APPLICATION NO.	FILING DATE	FIRST NAMED INVENTOR	ATTORNEY DOCKET NO.	CONFIRMATION NO.
10/065,021	09/11/2002	Artur Kurz	P6786.7US	7556
30008	7590 12/12/2005		EXAMINER	
GUDRUN E. HUCKETT DRAUDT			CADUGAN, ERICA E	
LONSSTR. 53 WUPPERTAL, 42289			ART UNIT	PAPER NUMBER
GERMANY	2, (220)		3722

DETAILED ACTION

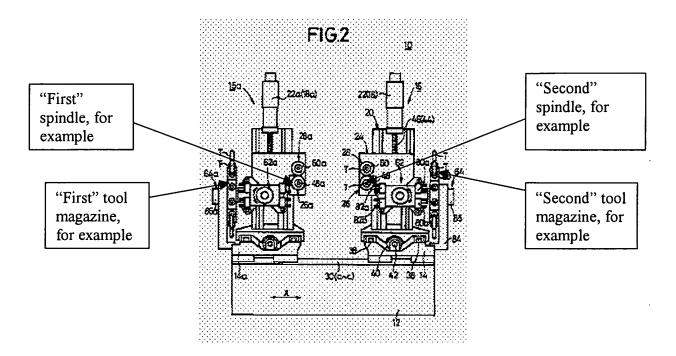
Thus, it appears that Applicant has interpreted the spindles 26 and 28 as the claimed "first" and "second" spindles. However, as set forth in both the previous rejection based on '835 as well as the above rejection based thereon, spindles 48 and 48a can be considered the claimed "first" and "second" spindles.

However, as set forth in the rejection(s) based on '835, the tool stockers are elements 60 (one for each side 16, 16a per paragraph 0023), which actually perform the "stocking" action of placing new tools in magazines 64 and 64a from storage area(s) 66 and removing old tools from magazines 64 and 64a and putting them into storage area(s) 66.

For clarity, Examiner has reproduced Figures 1 and 2 from '835 above, and has labeled examples of the first and second tool spindles and magazines, as well as the second tool stocker (60). Note that paragraph 0023, as described in the rejection, teaches that another identical tool stocker 60 is provided for the opposite main body side 16a, and thus, there is additionally a "first" tool stocker associated with the first spindle 48a and the first tool magazine 64a.
